BOARD OF BUILDING REGULATIONS AND STANDARDS

Geotechnical Advisory Committee (GAC) Meeting Minutes

September 8, 2021

2. Discuss proposed amendments and new content of 2021 IBC, Chapter 18, for inclusion in the Tenth Edition of the Massachusetts Building Code (780 CMR).

Additionally, on a **MOTION** by James Christensen, seconded by Chris Erikson, by **Roll Call Vote**, it was unanimously voted to approve revised **Figure 1806.4** as presented, reading:

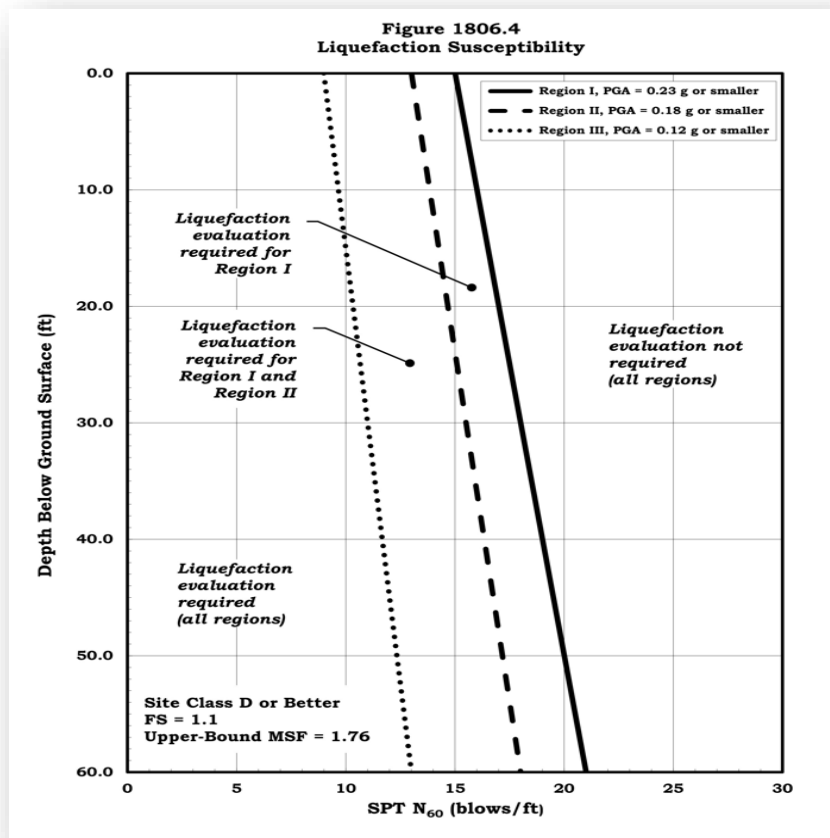
- **1806.4 – Liquefaction.** James Christensen reviewed his (*and M. Farren's*) memorandum with a revised date of September 7, 2021 (**EXHIBIT C**) relating to the input parameters and assumptions used in the calculation to develop revised Liquefaction Susceptibility Screening Plot in Figure 1806.4, indicating that SAC must decide whether or not to use the PGAs as suggested. Scott DiFiore indicated that the SAC has reserved space in Chapter 16 to address the issue and will ask Don Kelly to follow-up with James directly. Chairman Erikson noted that we may want to keep reference to alternate method as a precaution.

Figure 1806.4 is intended to be a screening tool for Site Classes A through D, determined in accordance with section 1613.5.2. The figure is based on Maximum Considered Geometric Mean Earthquake (MCE_G) Peak Ground Accelerations (PGAs) at outcropping Site Class B rock of 0.23 g, 0.18 g, and 0.12 g and site amplification factors (F_{PGA}) of 1.37, 1.44, and 1.56, respectively for Site Class D, and a factor of safety of 1.1. Refer to Table 1604.11 or USGS earthquake hazard data for PGA specific to where the site is located. This figure is based on observed behavior of clean sand, and is conservative for other (more silty) materials. Soils that do not screen out using Figure 1806.4 shall be evaluated for liquefaction per section 1803.5.12.

If the SPT N_{60} -values plot above or to the right of the applicable line in Figure 1806.4, the soil shall be considered not susceptible to liquefaction. Liquefaction for soils below a depth of 60 feet (18 m) from final grade need not be considered for level ground. For pressure-injected footings, the ten-foot (3-m) thickness of soil immediately below the bottom of the driven shaft shall be considered not susceptible to liquefaction.

Following discussion, on a **MOTION** by Chris Erikson, seconded by James Christensen, by **Roll Call Vote**, it was unanimously voted to approve revised **Section 1806.4.1** as presented, reading:

1806.4.1 Standard Penetration Test. For cases with a generally flat ground surface, the susceptibility to liquefaction may be evaluated using Figure 1806.4 on the basis of Standard Penetration Test ("SPT") blow counts, N (blows per foot) values that have been corrected for hammer efficiency to be SPT N_{60} (blows per foot) values. N_{60} -values are intended to be used with Figure 1806.4 and SPT N -values measured in the field should only be corrected for hammer energy. Hammer type shall be as described in ASTM Standard Method D6066. If the type of hammer is not known, Figure 1806.4 may be used assuming the SPT N -values were determined using a 140-lb donut drop weight and SPT N -values shall be corrected with a hammer efficiency correction factor (C_E) of 0.75.
